TAB F: FIVE DRAFT ENVIRONMENTAL IMPACT STATEMENT ALTERNATIVES (2007 – 2008)

DEIS Errata and Clarifications

Last updated: May 21, 2008

The following corrects errors in the I-5 Columbia River Crossing (CRC) Draft Environmental Impact Statement (DEIS) that was released for public review and comment on May 2, 2008. The Draft EIS will be further updated as errors are discovered or to clarify points of confusion. Such updates or corrections will be made either with additional errata or in the Final EIS anticipated to be released in summer 2009.

Exhibit 14 (page 2 of 2)

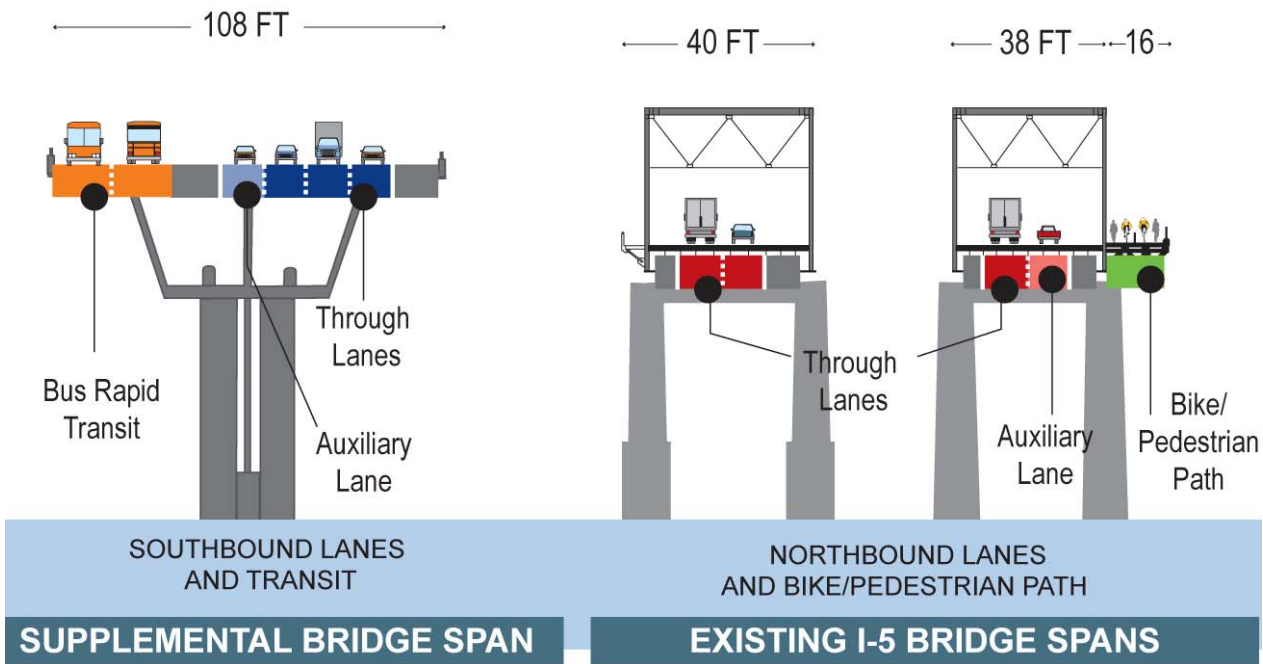
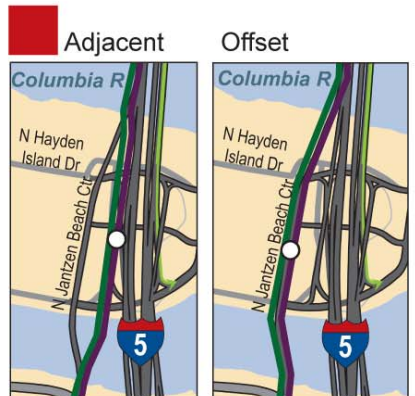
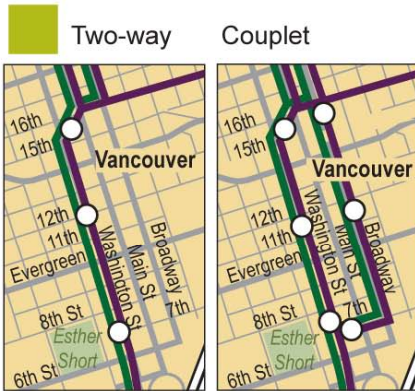
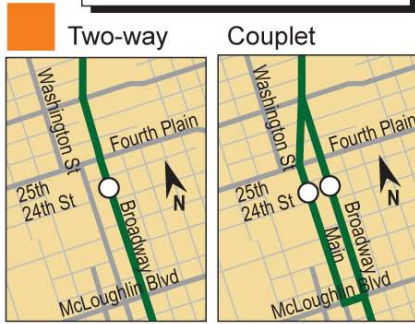
Summary	15	Exhibit 14: Adjacent inset shows N Jantzen Beach Ctr extending over North Portland Harbor	This crossing over North Portland Harbor does not exist, nor is it a CRC project alternative
Summary	17	Exhibit 15: Adjacent inset shows N Jantzen Beach Ctr extending over North Portland Harbor	This crossing over North Portland Harbor does not exist, nor is it a CRC project alternative
Summary	20	Exhibit 17: Key for Detailed Area of River Crossing displays a "3" in the colored label boxes corresponding with northbound and southbound through and auxiliary lanes.	The "3" was chosen to make the key consistent and is not meant to imply that there would be three through and three auxiliary lanes in both directions. Please refer to the graphic to the left of key for the actual number of lanes over the river crossing. The type of lane (i.e., northbound or southbound, through or auxiliary) is denoted by the color of the label box.

Exhibit 18

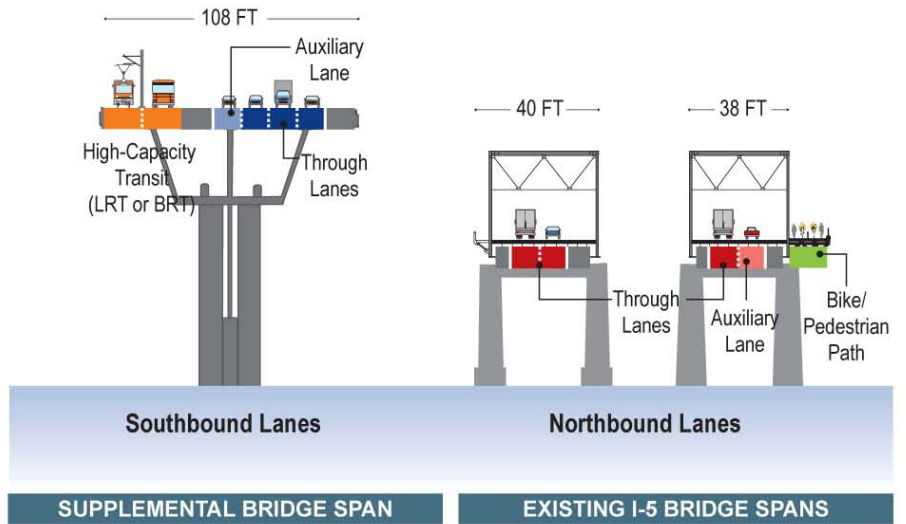
Summary	21	Exhibit 18: Key for Detailed Area of River Crossing displays a "3" in the colored label boxes corresponding with northbound and southbound through and auxiliary lanes.	The "3" was chosen to make the key consistent and is not meant to imply that there would be three through and three auxiliary lanes in both directions. Please refer to the graphic to the left of key for the actual number of lanes over the river crossing. The type of lane (i.e., northbound or southbound, through or auxiliary) is denoted by the color of the label box.
Summary	23	Exhibit 21 states "two-way Broadway" in the legend for a downtown Vancouver transit alignment option	Two-way Washington
Summary	23	Exhibit 21 shows the two-way Broadway alignment option in northern Vancouver on Main Street	This alignment option should be shown on Broadway

Exhibit 21
Transit Terminus and Alignment Options

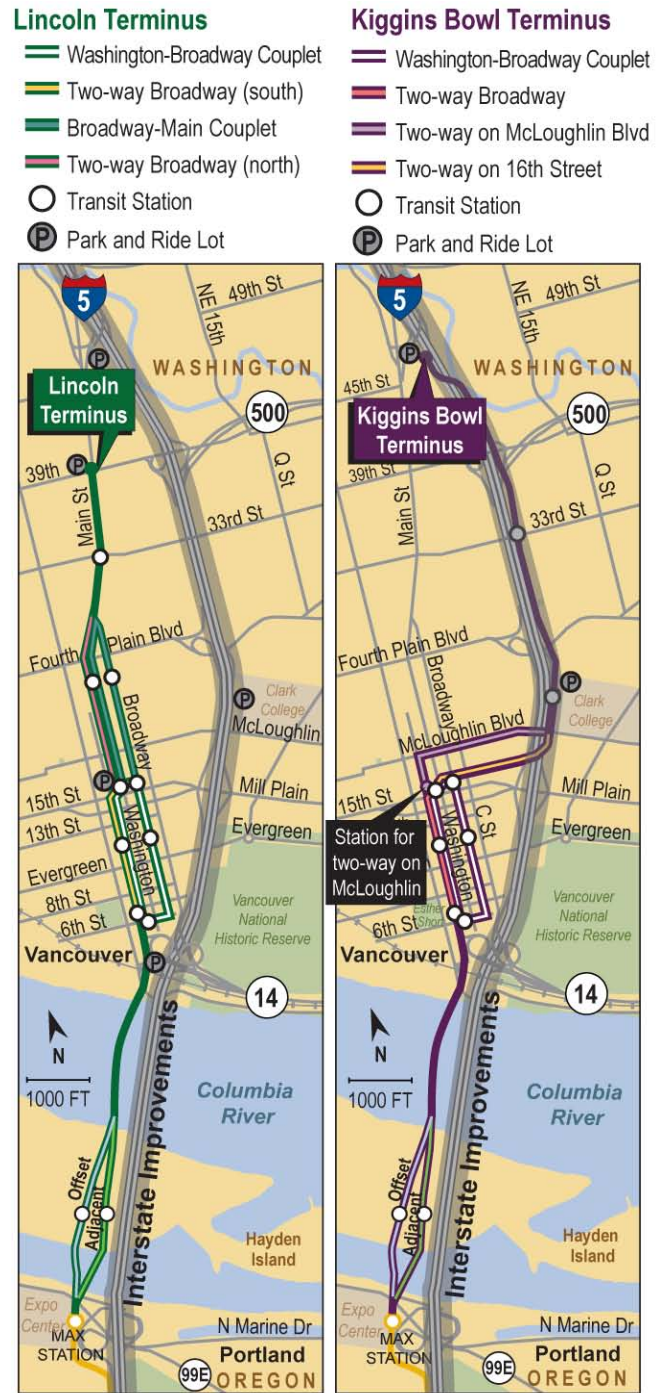
CHAPTER	PAGE	CURRENT TEXT	CORRECTED TEXT/CLARIFICATION
Summary	23	Exhibit 21 shows Park and Rides near the I-5 SR 14 interchange and near Mill Plain Blvd for the Lincoln Terminus option	These Park and Rides should be deleted for this terminus option, as they only apply to the Mill Plain MOS
Summary	24	Exhibit 22 incorrectly characterizes the park and rides paired with the Clark College MOS and Mill Plain MOS	Clark College MOS: Clark College (surface lot) (structure) Mill Plain MOS: SR-14 (surface and structure) and Mill Plain (structure)
Summary	24	Exhibit 22 lists the following total park and ride stalls included for each terminus option: 2,410 (Kiggins Bowl), 1,250 (Lincoln), 2,410 (Clark College), 2,365 (Mill Plain)	Each terminus option could be associated with a variety of park and ride options. However, the approximate number of spaces assumed in the DEIS analysis are: 2,500 (Kiggins Bowl), 2,410 (Lincoln), 1,250 (Clark College), 3,220 (Mill Plain).
